SEAF-RA

ASP-161074-01

SHEET 2 OF 2

DETAIL 'B'
SCALE 10 : 1

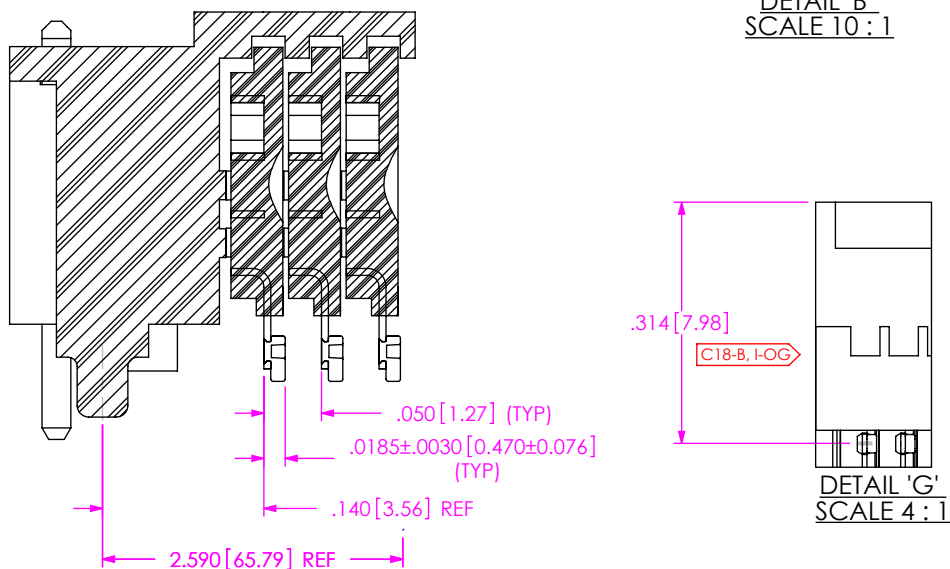
TOP VIEW: ADD REF C ON 3.270, "TYP (TO WAFER)" ON 522, CHG 542 TO 592, C1-B-CP TO C1-B, I-LOG, FRONT VIEW: CHG 050 TO 0500, 140 REF TO 140 *F, .007, 2.450 TO 2.590, C2-B-MV TO C2-B, I-LOG, C3-B-MV TO C3-B, I-LOG, C4-B-MV TO C4-B, I-LOG, C5-B-MV TO C5-B, I-LOG, C7-B-MV TO C7-B, I-LOG, REM C7 FROM 120, TO 140, DEL 120, ADD "SEE NOTE #8" ON 140 & 1590, BTM VIEW: MOD APIN POSITION, ADD DIA .044; SIDE VIEW: DEL DIA .044; NOTES: ADD NOTE 8 & 9; MAT'L: ADD C19; ADD REF BLOCK AND CPG CATE, SHT 2, SECT "A"-A: CHG 036 w/ .005 TO 0.36 & 0.05+; C09-B-MV TO C9-B, I-LOG, C10-B-CP TO C10-B-MV, DEL 315, C11, C12, C14; DET 'B': CHG .0020 TO .002, .004 TO .002, DEL C16, ADD "SEE NOTE 4" ON .002; ADD SECT "F": DET 'G' & DET 'G'
